Response-to-Departmental Comments Table

Amendment of Plan to Rezone from “Residential (Group D)” (“R(D)”), “Residential (Group E)” (“R(E)”) and an area shown as ‘Road’ to “Residential (Group C)3) (“R(C)3”) on the Approved Ho Chung Outline Zoning Plan No. S/SK-HC/11 Various Lots in Demarcation District 210 and Demarcation District 244 and Adjoining Government land Ho Chung, Sai Kung, New Territories, Hong Kong

Responses to Comments from Government Departments via Planning Department’s email on 12.12.2023 on the Further Information 02 (FI02) issued on 15.11.2023

Drawn	HY	Date	18/12/2023	Drawing No.	Fig. 5.2
Checked	RT	Approved	FW	Rev.	-
Scale	1:500 @ A3

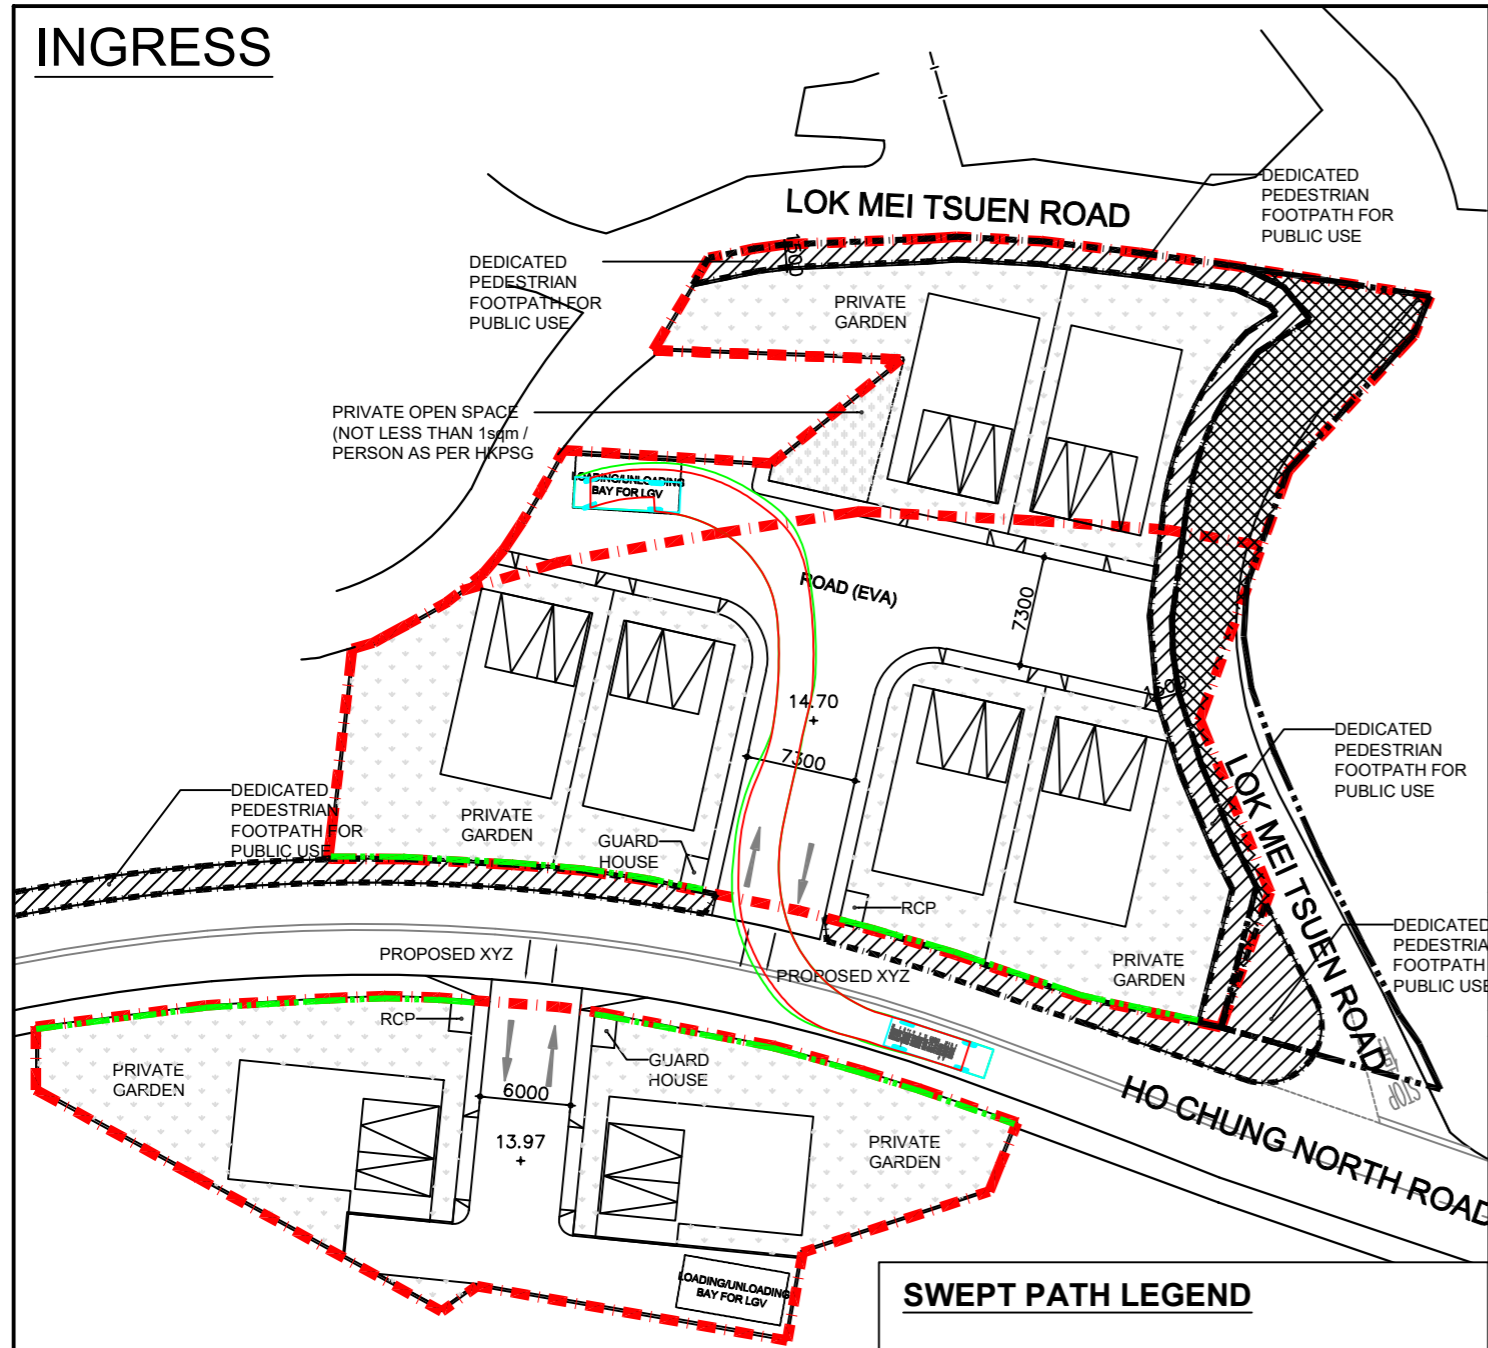
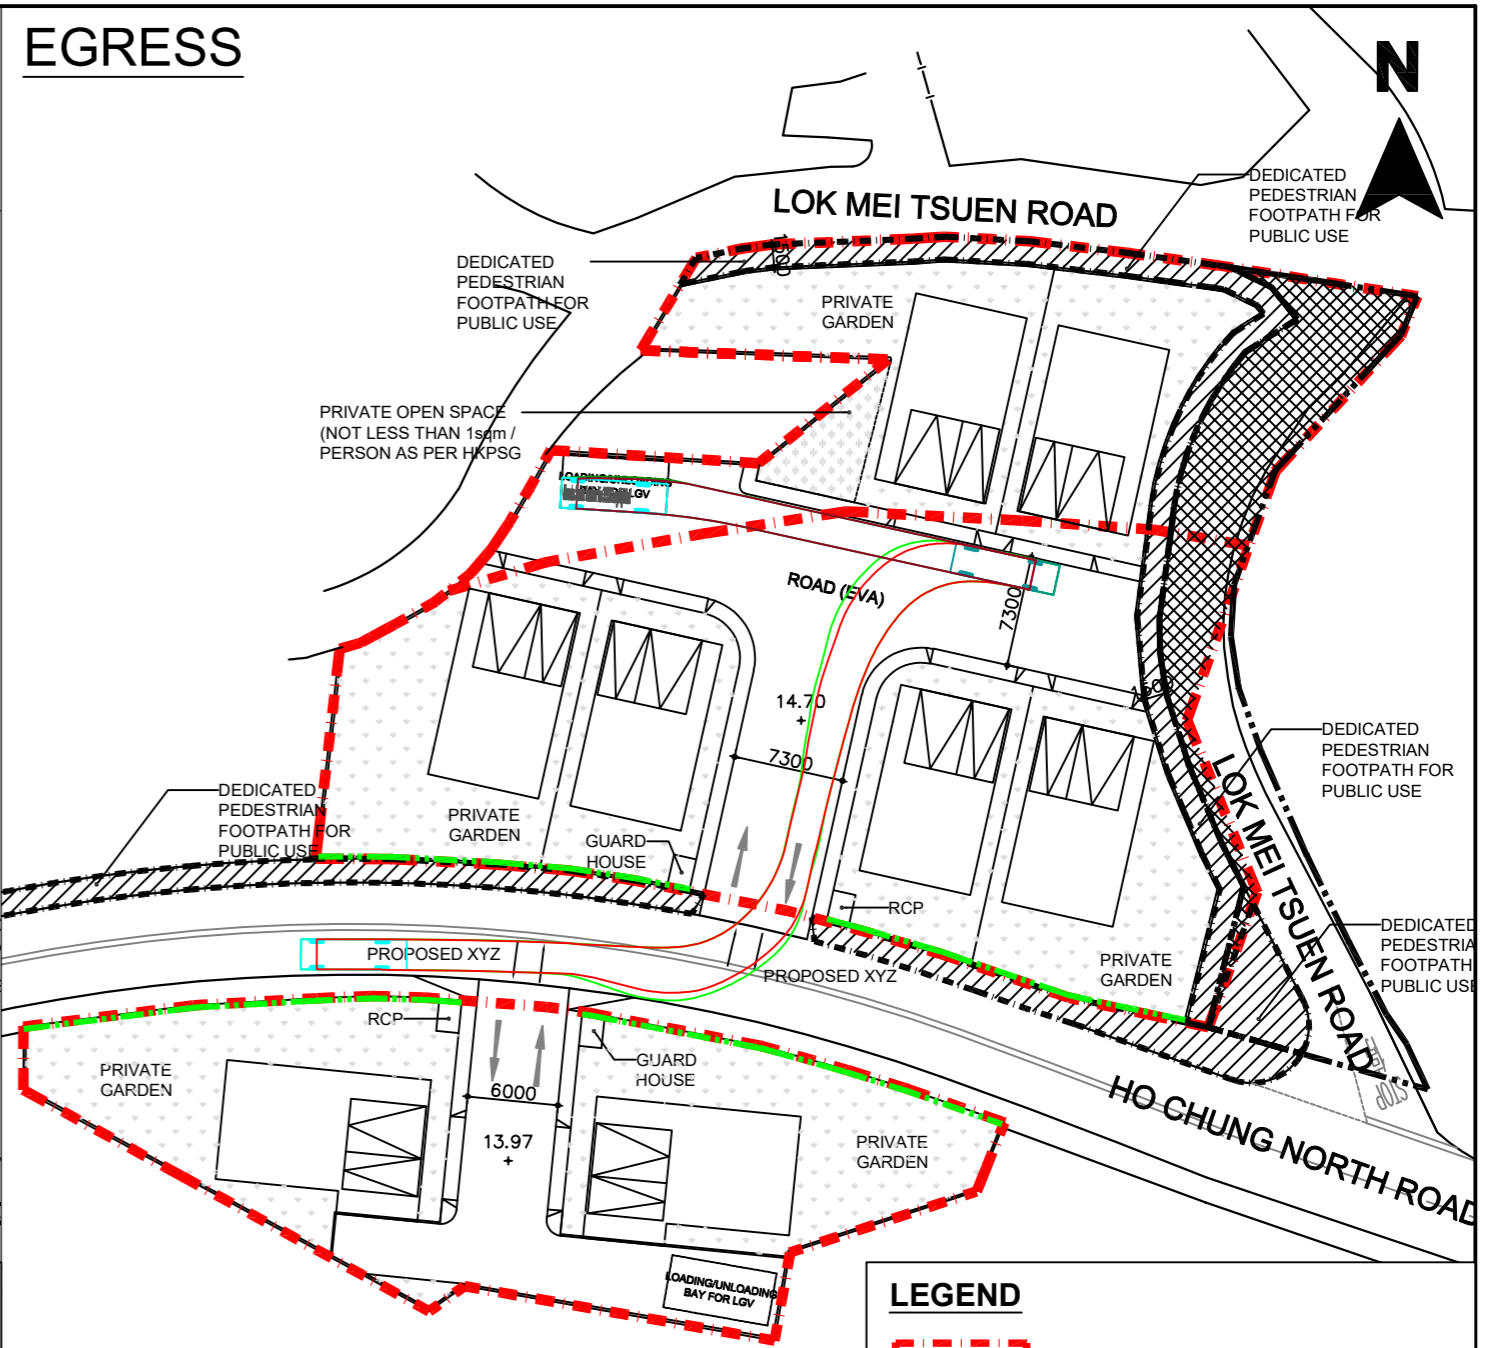
TD – TIA4	<u>Figure 5.2</u> please include the traffic aid, e.g. road marking in the drawing.	All associated figures have been updated in the TIA (Ver. C) as Appendix 1 of the attached PS (Ver. C) to include the traffic aid.

TD – TIA5	<u>Figure 5.2</u> it is noted that the egress out of the proposed development would encroach to the opposite lane in Ho Chung North Road. Please clarify.	The egress route was wrongly taken to eastward in the previous Traffic Impact Assessment (Version B) (TIA (Ver. B)). The correct egress route should be westward to have shortest route to Kowloon bound. The updated swept path in TIA (Ver. C) demonstrated egress vehicles will not unnecessarily encroach to the opposite lane in Ho Chung North Road.
TD – TIA6	<u>Figure 5.2 and Figure 5.3</u> Please provide the swept path for vehicular access to the site.	Noted. The swept path for vehicular access to the site have been provided. Figure 5.2 and 5.3 has been updated in the TIA (Ver. C) as Appendix 1 of the attached PS (Ver. C).
TD – TIA7	Subject to the applicant's response to our comments, we reserve our comments to the assessments upon receiving further information.	Noted.

Drawing No.
Fig. 5.4

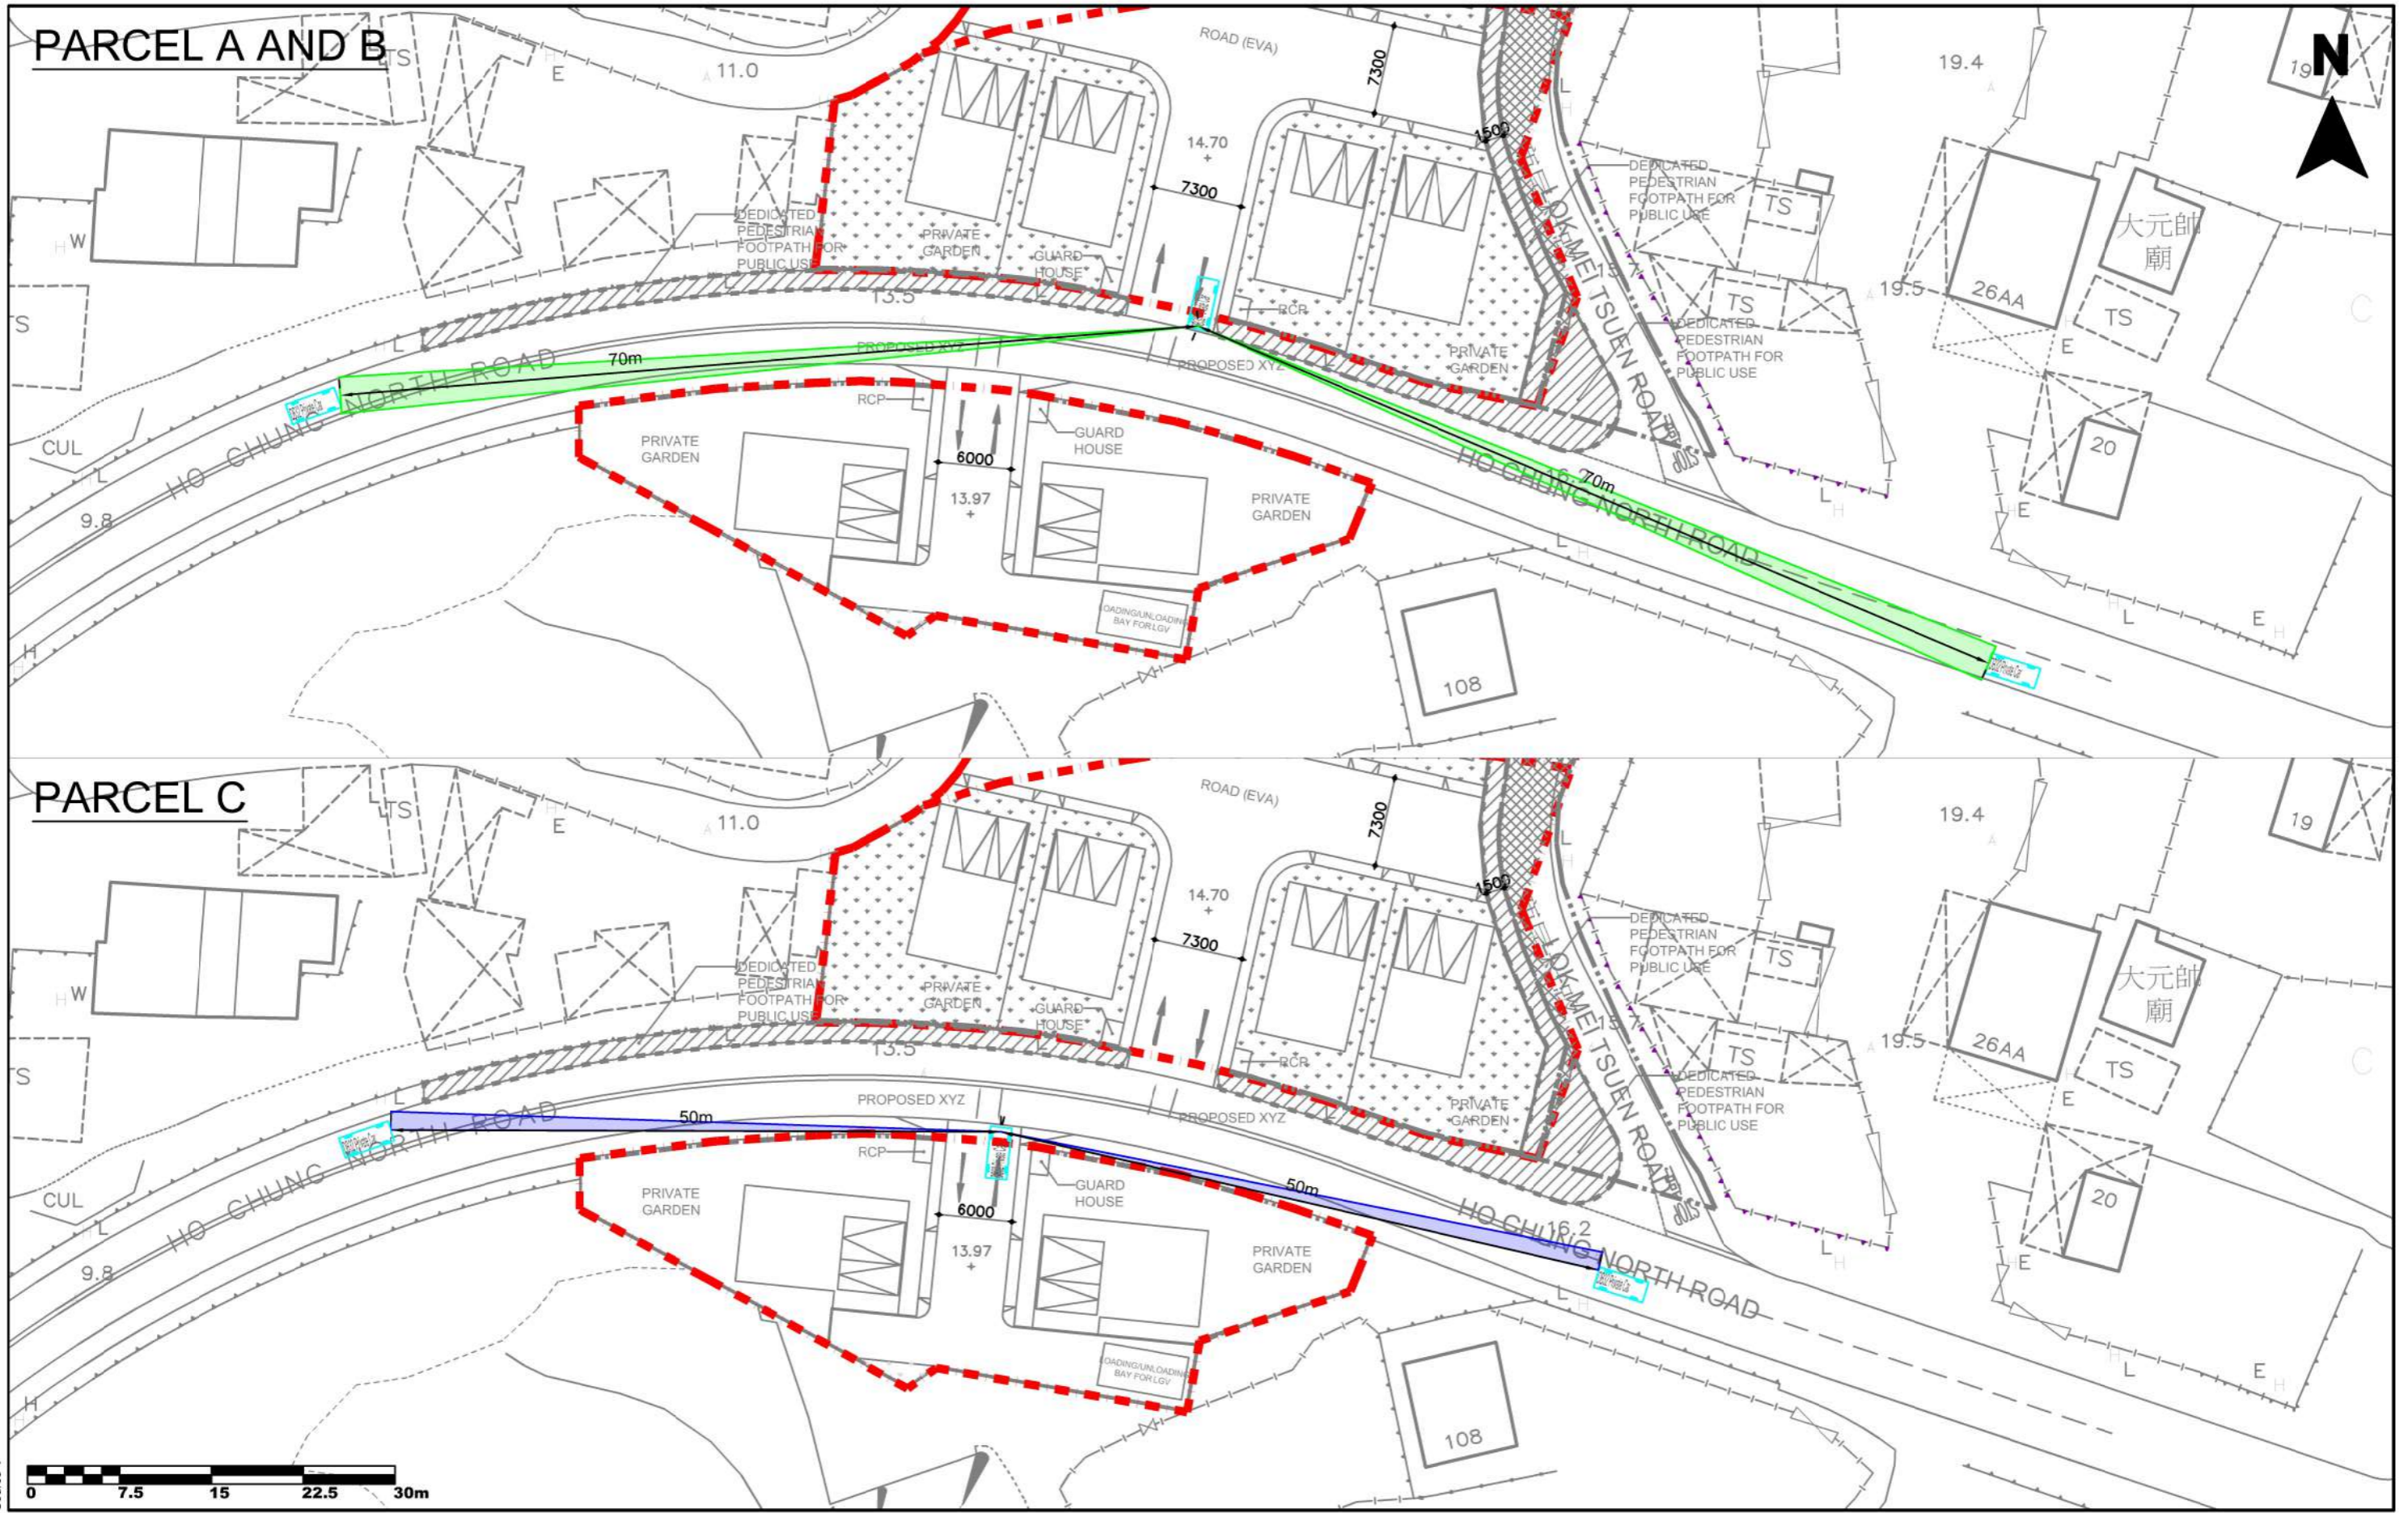
Item	Comments	Responses
TD – TIA1	<u>Section 3.1.3</u> Our previous comment to include the Pak Wai roundabout in the study has not been addressed by the applicant.	The wordings "Pak Wai Roundabout" was missing in Section 3.1.3. However, this junction was assessed in Section 4 of the TIA (Ver. B). Since no development traffic was assigned to it, there are nil traffic impact expected due to the proposed development. Section 3.1.3 was rectified in latest Traffic Impact Assessment (Version C) (TIA(Ver. C)) as Appendix 1 of Attachment 1 Planning Statement (Version C) (PS (Ver. C)).
TD – TIA2	<u>Section 5.1.1</u> please justify not providing loading/unloading area and turning facilities in Parcel C.	One loading/unloading area and turning facilities will be provided in Parcel C. Section 5.1.1 and associated Figures have been updated in the TIA (Ver. C) as Appendix 1 of the attached PS (Ver. C).
TD – TIA3	<u>Section 5</u> please demonstrate the sight distance at the vehicular access.	The sight distance at the vehicular access has been added. Please see Figure 5.4 of the TIA (Ver. C) for the sightline analysis.
